**Explanation of Intended Effect (Draft Design and Place SEPP)–
Canterbury Bankstown Council Submission**

Submission to the Explanation of Intended Effect for a Design and Place SEPP

Canterbury Bankstown Council's Submission to the Explanation of Intended Effect for a Design and Place SEPP

Ref: Local Housing Strategy Guideline (Department of Planning, Industry and Environment, 2018)

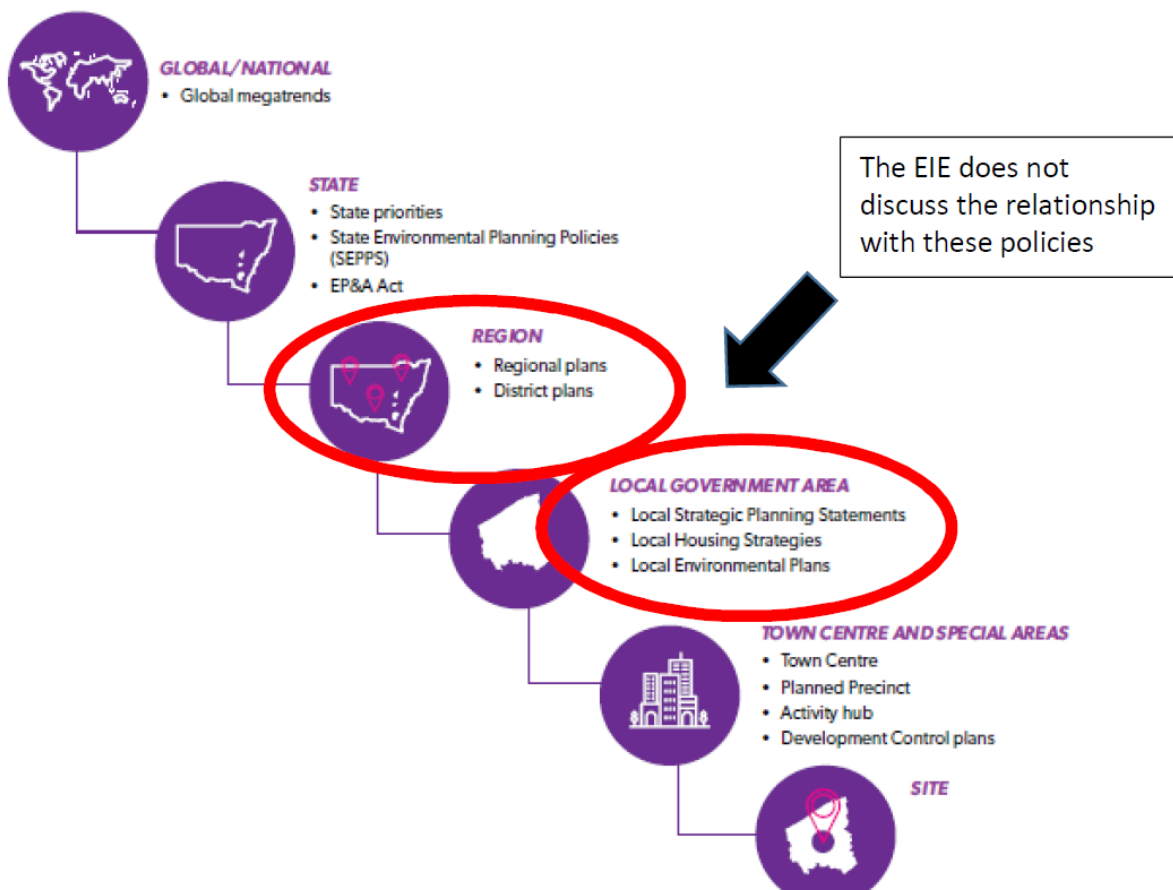
The Explanation of Intended Effects (page 38) highlights the relationship with SEPPs, LEPs and DCPs. The issue is there is no discussion about the relationship with the Greater Sydney Region Plan, District Plans, Local Strategic Planning Strategies, Local Housing Strategies and Local Character Statements.

The issue is, at this late stage in the process, the Draft SEPP (page 30) proposes to set baseline residential density targets in the R1 to R4 zones. This proposal is inconsistent with the place-based planning approach and does not consider local context. It would erode the substantial body of strategic planning work this Council and others have put into the new planning framework. Furthermore, the implications of not meeting the targets is unclear and creates uncertainty for the integrity of Council's zoning controls.

- Outline the relationship with the Greater Sydney Region Plan, District Plans, Local Strategic Planning Strategies, Local Housing Strategies and Local Character Statements.
- Do not set baseline residential density targets in the R1 to R4 zones.
- Council to continue to determine appropriate densities in the R1 to R4 zones in accordance with *Connective City 2036*, Housing Strategy and community consultation.
